SUBJECT: PALO VERDE NUCLEAR GENERATING STATION, UNIT 3 – RELIEF
REQUEST 54 TO APPROVE AN ALTERNATIVE TO FLAW REMOVAL FOR
REACTOR COOLANT PUMP 2A SUCTION PRESSURE INSTRUMENT
NOZZLE (CAC NO. MF6806)

SAFETY EVALUATION BY THE OFFICE OF NUCLEAR REACTOR REGULATION
RELIEF REQUEST 54 REGARDING PROPOSED ALTERNATIVE FOR REPAIR OF
INSTRUMENT NOZZLE AT REACTOR COOLANT PUMP 2A
ARIZONA PUBLIC SERVICE COMPANY
PALO VERDE NUCLEAR GENERATING STATION, UNIT 3
DOCKET NO. 50-530

Figure 1-1. RCP 2A Instrumentation Nozzle Repair Schematic

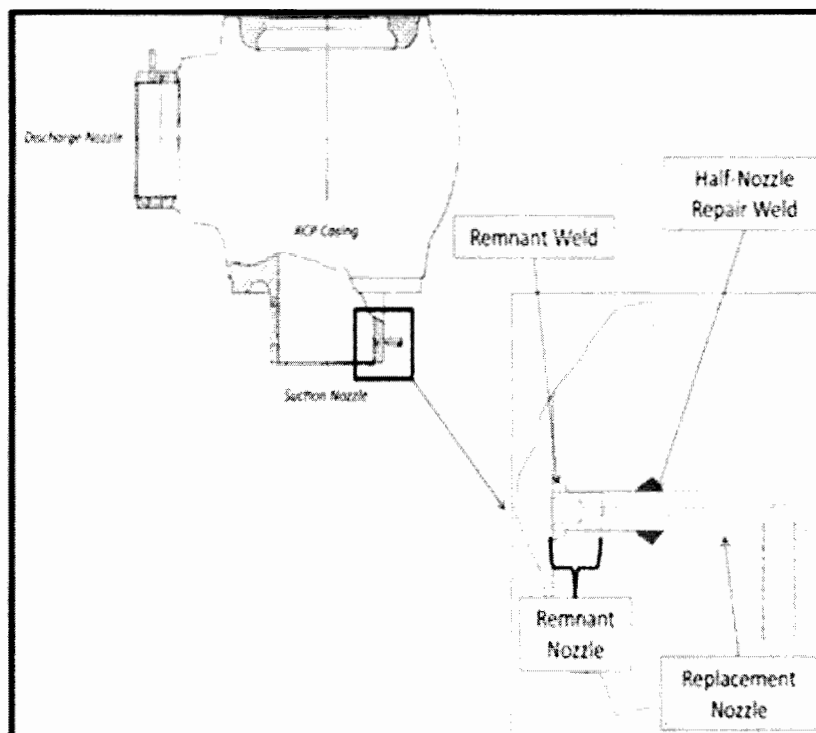
During the 3R18 spring 2015 refueling outage at PVNGS, Unit 3, the licensee performed a half-nozzle repair of the RCP suction safe end Alloy 600 instrument nozzle due to leakage in the annulus between the outer surface of the instrument nozzle and the bore on the suction safe end. The Alloy 600 instrument nozzle is attached with a partial penetration weld to the inside of the RCP suction safe end using Alloy 82/182 weld filler metal. The licensee stated that the most likely location of the flaw(s) that caused the leakage is in the PWSCC-susceptible Alloy 82/182 weld and the Alloy 600 instrument nozzle, along their fusion line inside the safe end bore. The half-nozzle repair entailed severing the instrument nozzle on the outside of the RCP suction safe end, followed by machining out a portion of the nozzle inside the bore. The removed portion of the Alloy 600 instrument nozzle was then replaced with a section (half-nozzle) of more PWSCC-resistant Alloy 690 material which was welded to the outside surface of the suction safe end using Alloy 52M weld filler material. A small gap is left between the new Alloy 690 replacement nozzle and the remaining Alloy 600 nozzle which allows reactor coolant to enter the crevice region between the carbon steel (SA-508, Class 1) RCP suction safe end material, Alloy 690 replacement nozzle and the remaining Alloy 600 nozzle material. A schematic of the repair is provided Figure 1-1 below. The licensee stated that half-nozzle repairs have been successfully implemented on 73 Alloy 600 small-bore RCS hot-leg nozzles.
